Subject: **Palo Verde Nuclear Generating Station (PVNGS)**
Units 1, 2, and 3
Docket Nos. STN 50-528, 50-529, and 50-530
Response to Request for Additional Information Regarding License
Amendment Request (LAR) to Revise Technical Specification 3.7.4,
Atmospheric Dump Valves (ADV)s

**RESPONSE TO REQUEST FOR ADDITIONAL INFORMATION
REGARDING LICENSE AMENDMENT REQUEST TO REVISE
TECHNICAL SPECIFICATION 3.7.4,
*ATMOSPHERIC DUMP VALVES (ADV)s***

Figure 1-1. Critical Flow Mass Flux Predicted by the Henry-Fauske Correlation and the Homogeneous Equilibrium Model for an Upstream Stagnation Pressure of 2000 psia

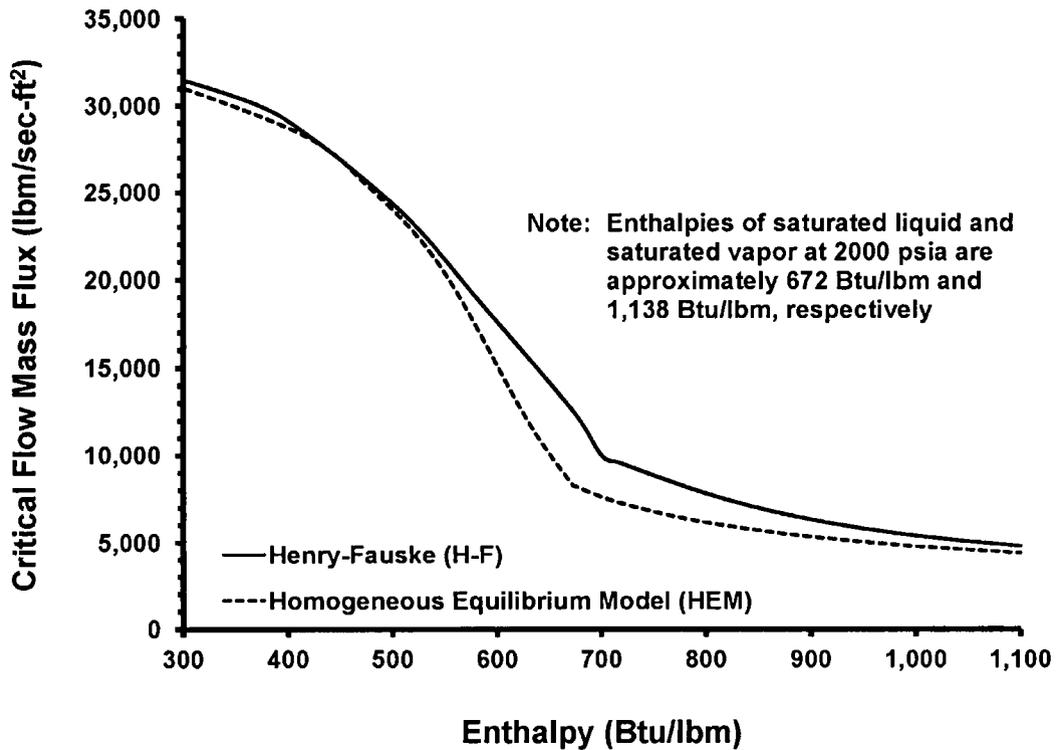
- a. Please provide a tabulated sequence of events for the supplemental analysis.
- b. Please provide a comparison of the Henry-Fauske break flow model to the Homogenous Equilibrium Model including a plot of SG tube flow versus time that compares the design basis analysis to the supplemental analysis. Provide this comparison for a period of time that extends to the time that the ADVs are assumed to actuate in the design basis analysis and discuss the effect that any other significant differences aside from the break flow model have on the compared results.

The H-F correlation also incorporates an empirically-derived function such that, as the quality upstream of the break increases, the correlation will more closely approximate the HEM. See, for example, Figure 1-1 in Attachment 2 to this enclosure, which compares the two models for an upstream stagnation pressure of 2000 psia. The inflection point on the HEM curve at about 672 Btu/lbm corresponds to the enthalpy of saturated liquid. This also happens to be the point at which the predictions made by the two models differ the most. At higher values of enthalpy, quality increases and the curves become more similar.

For SGTR simulations that model the presence of subcooled liquid upstream of the break location, the H-F correlation will typically predict a higher break flow rate than the HEM. As Figure 1-1 suggests, however, the difference between HEM and H-F predictions will vary with the amount of subcooling, which is likewise sensitive to changes in pressure. Thus selection of the proper model will depend upon the specific purpose of a simulation, as well as how system parameters change with time throughout the simulation.

higher break flow rate than the HEM. Thermodynamic conditions at this point in time were near the inflection point shown on Figure 1-1, where the difference between HEM and H-F correlation predictions is maximized.

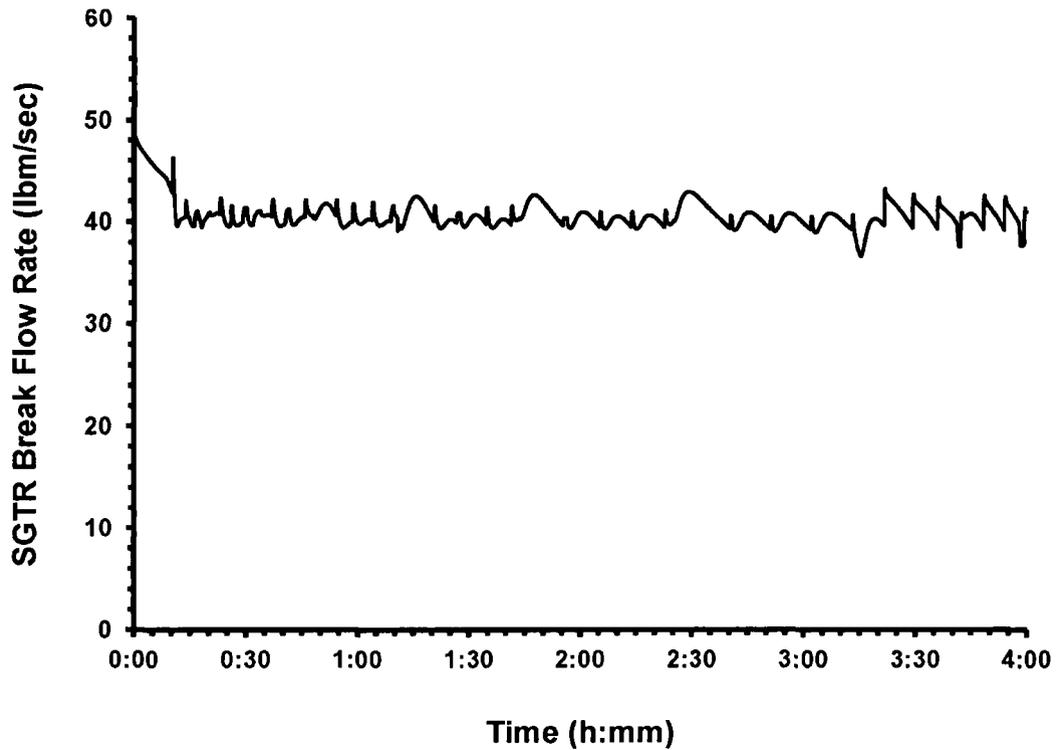
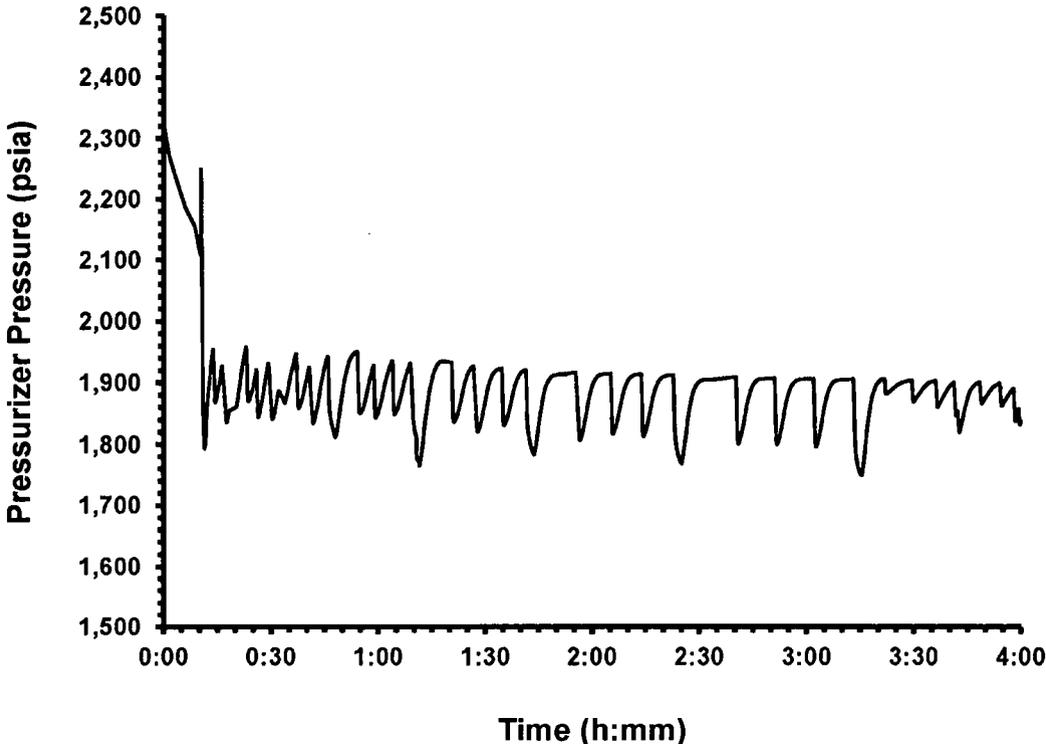
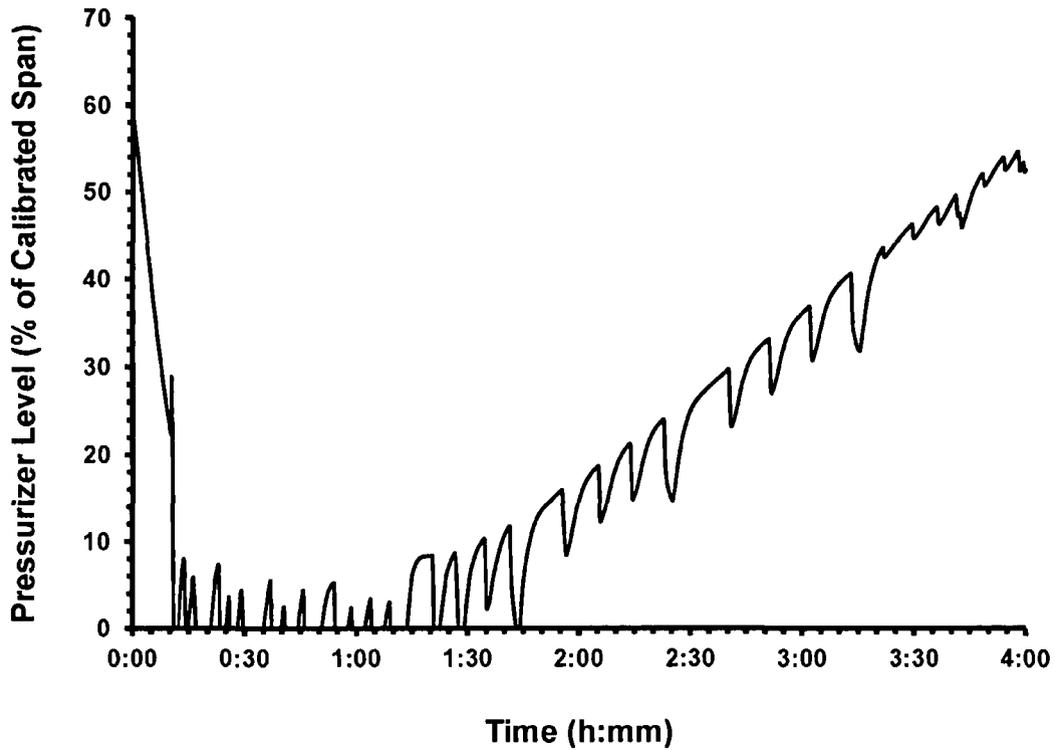
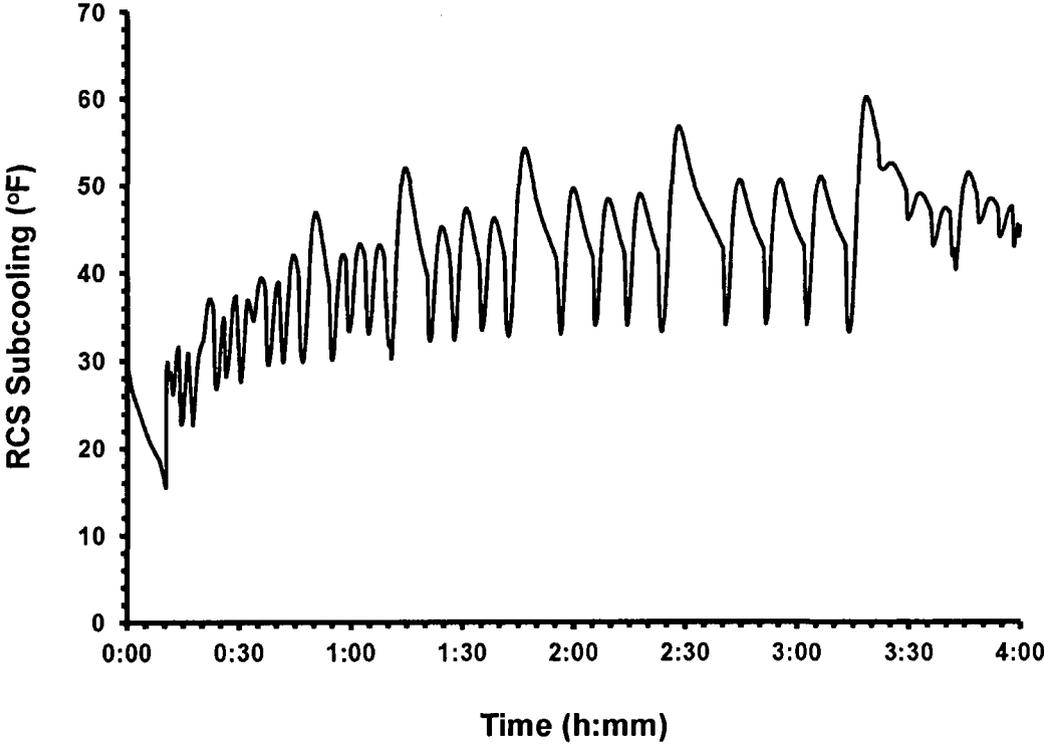
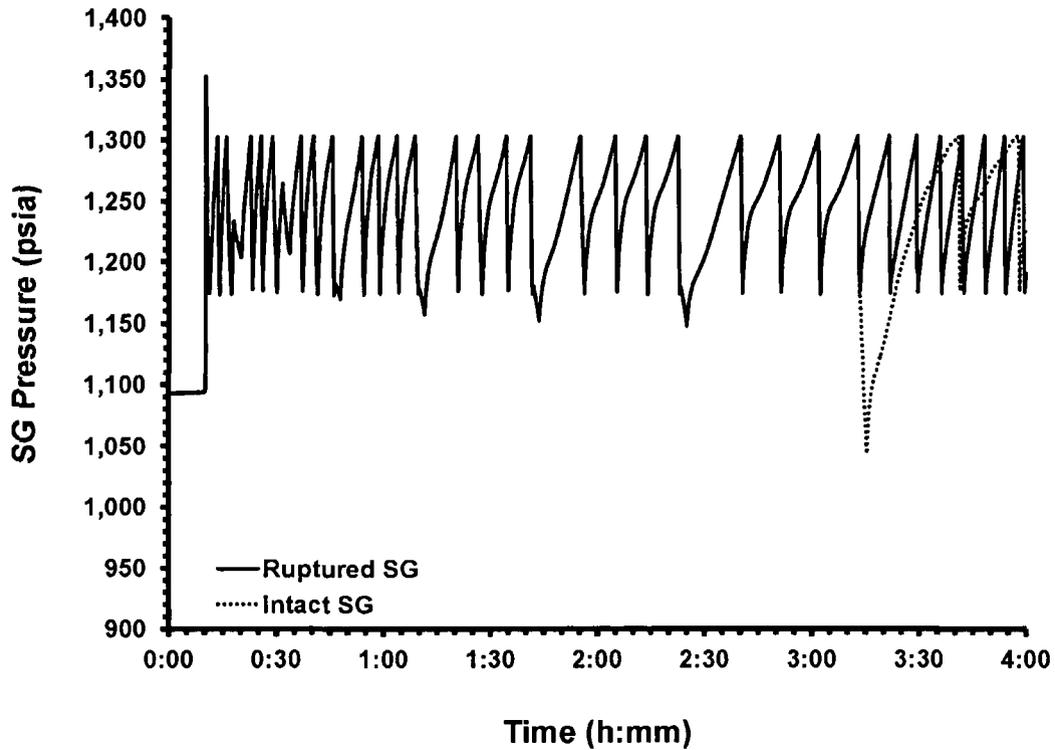
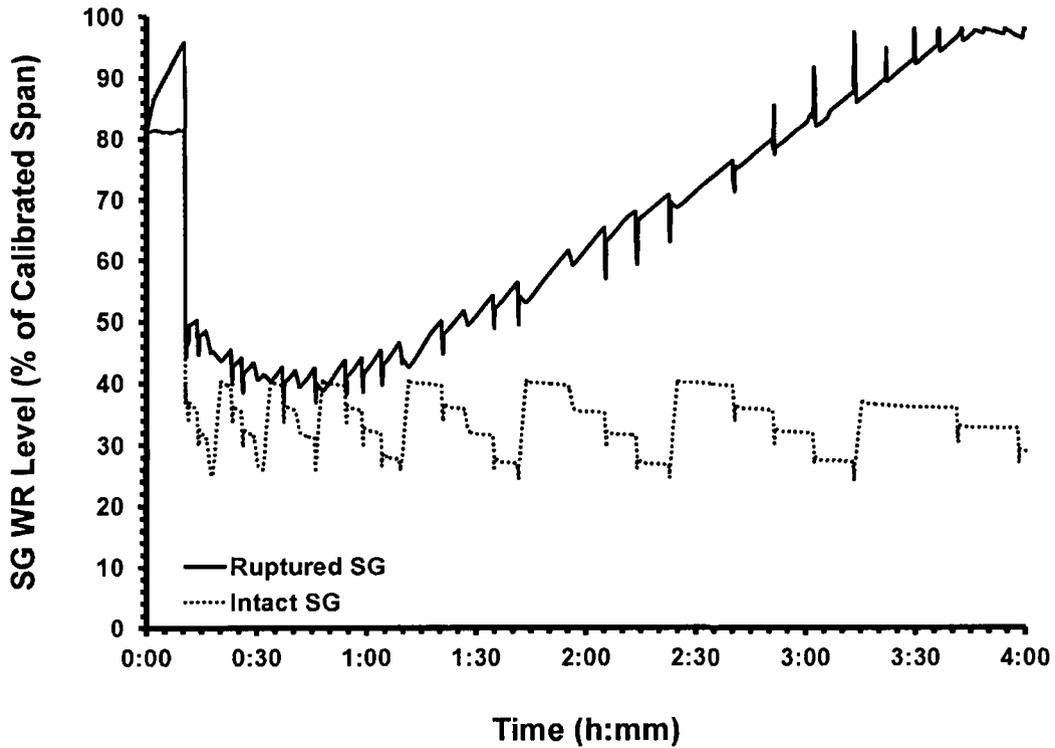
- c. Please provide plots of the following parameters as functions of time:
 - i. Leak flow rate
 - ii. Pressurizer pressure
 - iii. Pressurizer volume
 - iv. RCS subcooling

- Figure 1-3 SGTR Demonstration Analysis – SGTR Break Flow Rate vs. Time
- Figure 1-4 SGTR Demonstration Analysis – Pressurizer Pressure vs. Time
- Figure 1-5 SGTR Demonstration Analysis – Pressurizer Level vs. Time
- Figure 1-6 SGTR Demonstration Analysis – Reactor Coolant System Subcooling vs. Time
- Figure 1-7 SGTR Demonstration Analysis – Steam Generator Pressure vs. Time
- Figure 1-8 SGTR Demonstration Analysis – Wide Range Steam Generator Level vs. Time

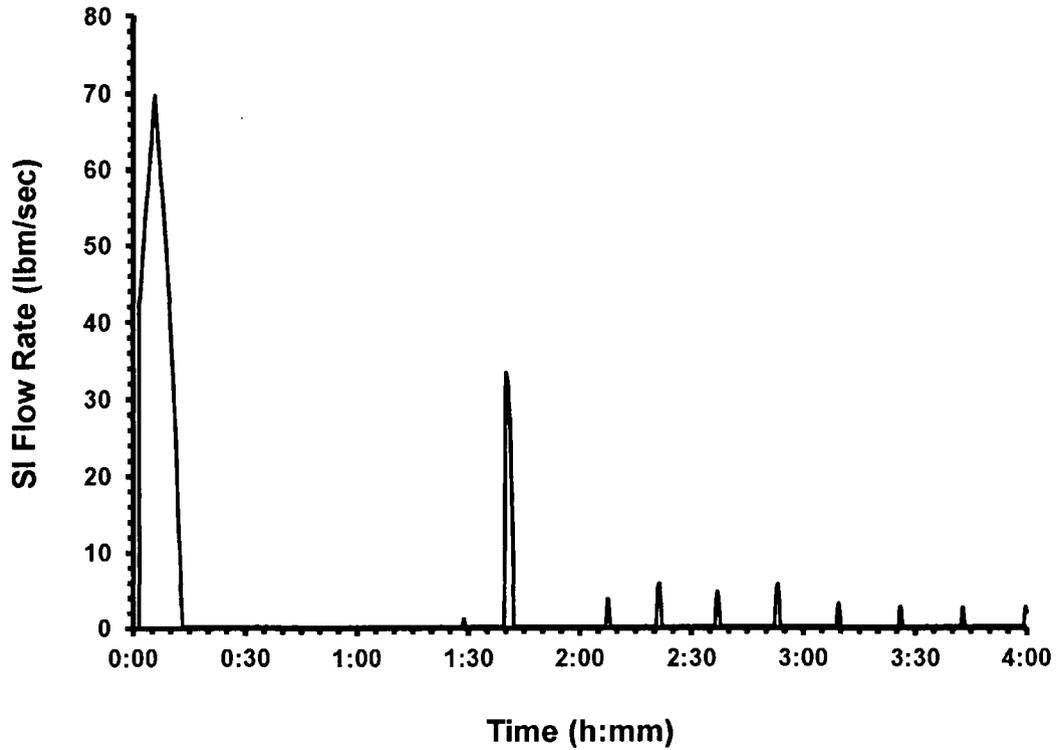
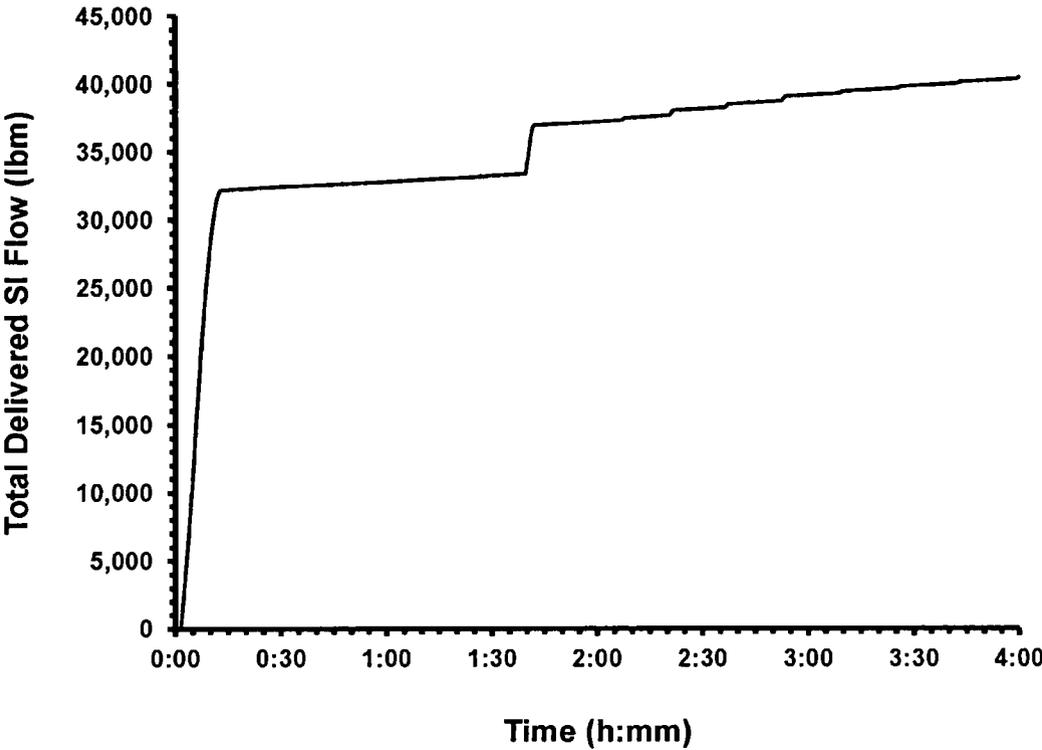
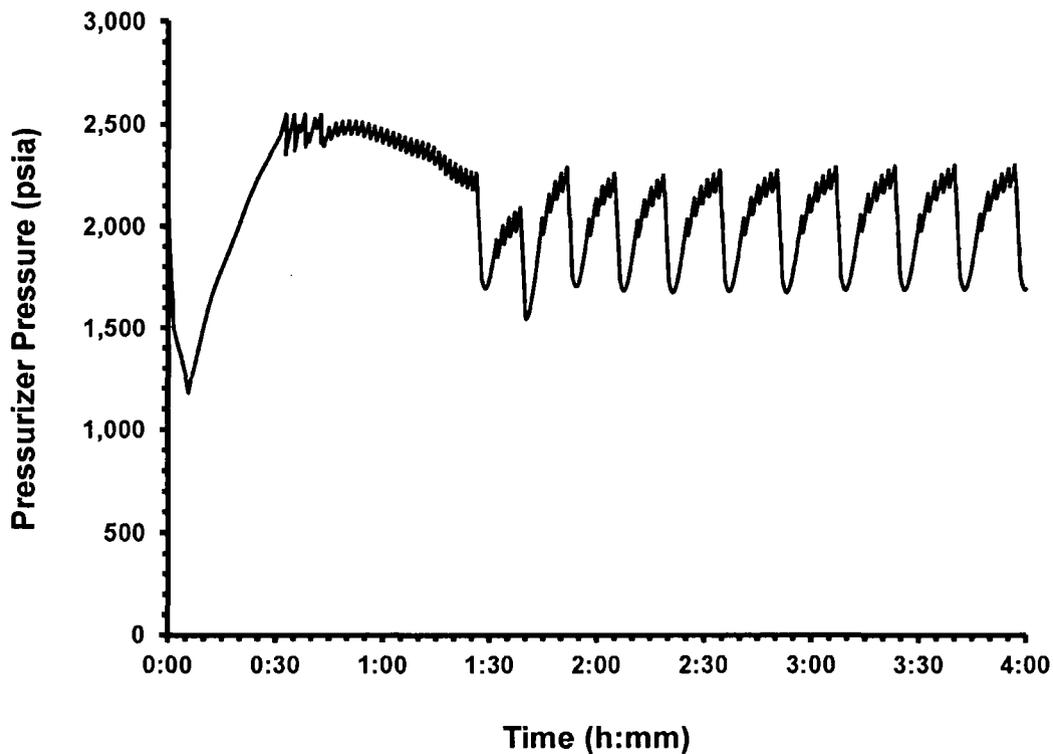
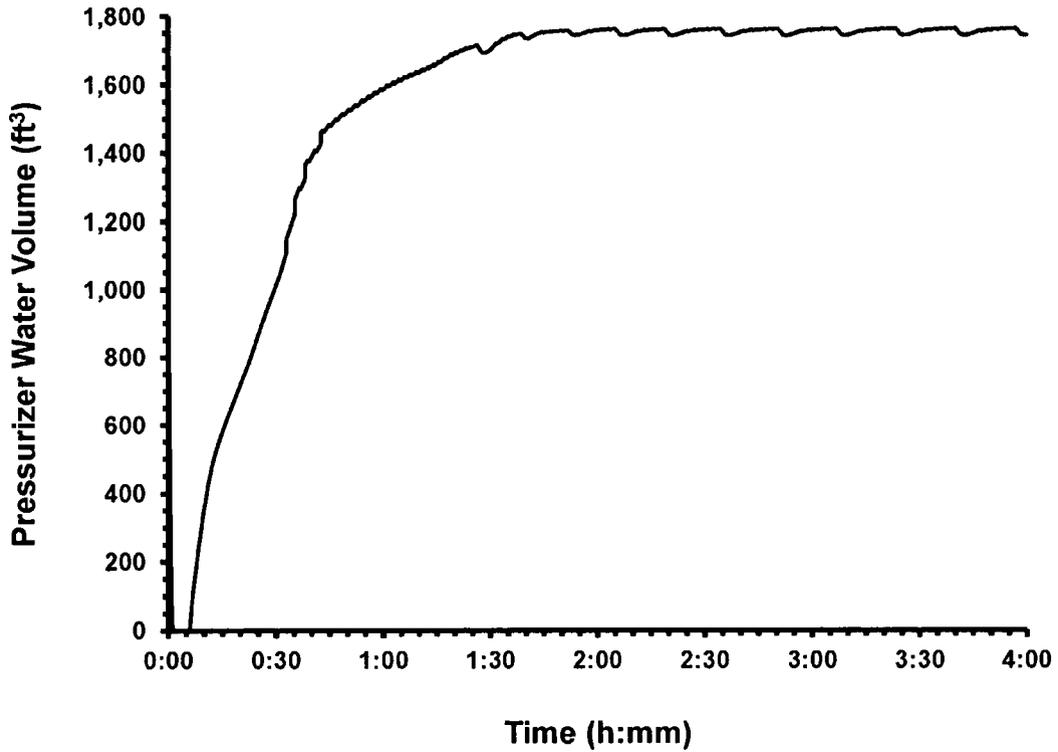
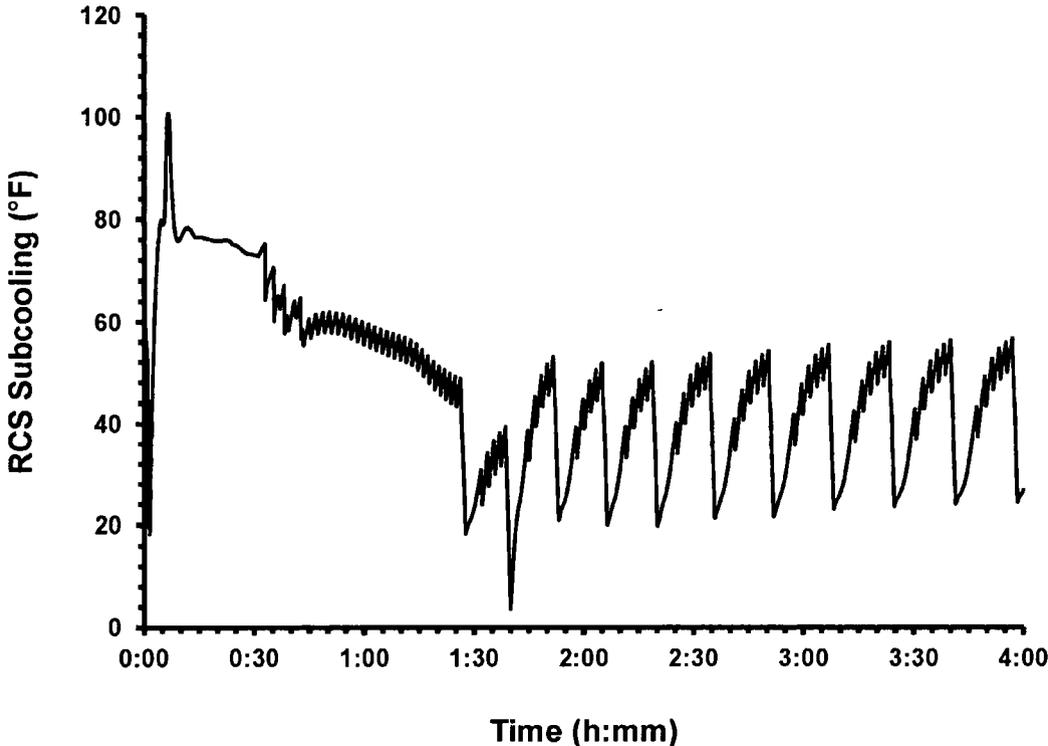
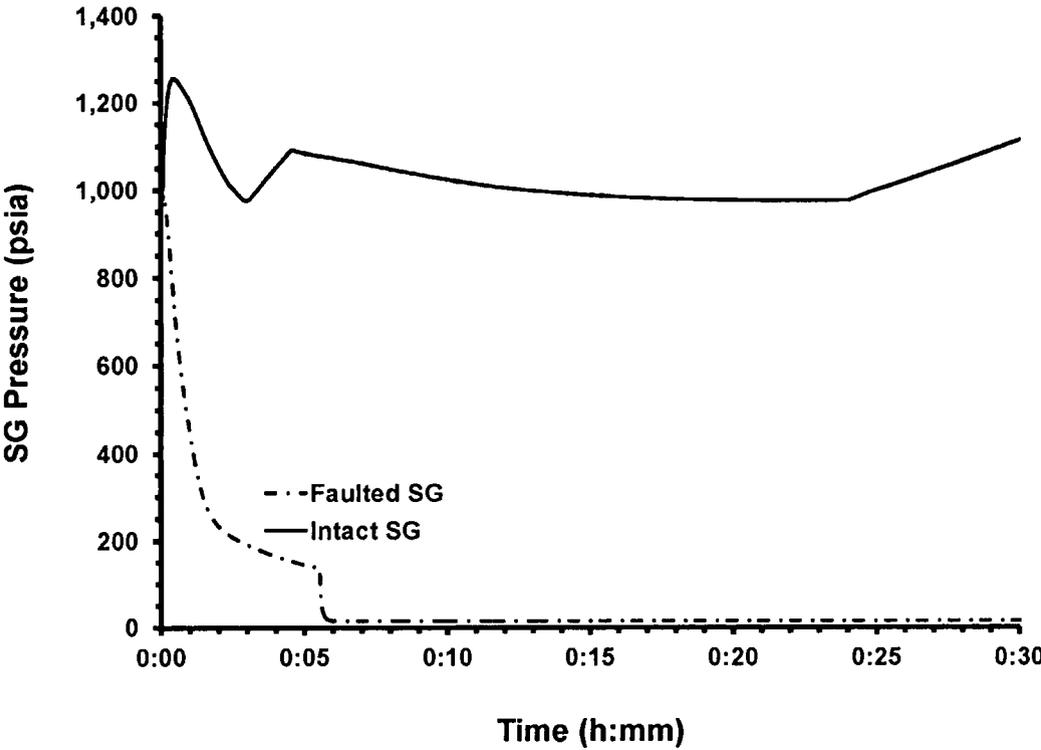
- a. Please provide a table of results that includes key system attributes such as peak RCS pressure, maximum and minimum pressurizer level, and the sequence of events. Identify the acceptance criteria for pressurizer fill and for water entrainment in the pressurizer safety valve (PSV) effluent.
- b. Please provide plots of the following parameters as functions of time. The NRC staff acknowledges that some plots may need to be truncated if a stable or quasi-stable condition is reached. If this is done, please describe the system behavior for the period that is not included.
 - i. Instantaneous SI flow
 - ii. Total SI flow
 - iii. Pressurizer pressure
 - iv. Pressurizer volume
 - v. Subcooling margin
 - vi. Steam generator pressure
 - vii. Steam generator level

- Figure 2-1 MSLB Demonstration Analysis – Instantaneous Safety Injection Flow Rate vs. Time
- Figure 2-2 MSLB Demonstration Analysis – Total Delivered Safety Injection Flow vs. Time

- Figure 2-3 MSLB Demonstration Analysis – Pressurizer Pressure vs. Time
- Figure 2-4 MSLB Demonstration Analysis – Pressurizer Water Volume vs. Time
- Figure 2-5 MSLB Demonstration Analysis – Reactor Coolant System Subcooling vs. Time
- Figure 2-6 MSLB Demonstration Analysis – Short-Term Steam Generator Pressure vs. Time
- Figure 2-7 MSLB Demonstration Analysis – Long-Term Steam Generator Pressure vs. Time
- Figure 2-8 MSLB Demonstration Analysis – Short-Term Wide Range Steam Generator Level vs. Time
- Figure 2-9 MSLB Demonstration Analysis – Long-Term Wide Range Steam Generator Level vs. Time
- Figure 2-10 MSLB Demonstration Analysis – Short-Term Reactivity Change vs. Time
- Figure 2-11 MSLB Demonstration Analysis – Long-Term Reactivity Change vs. Time
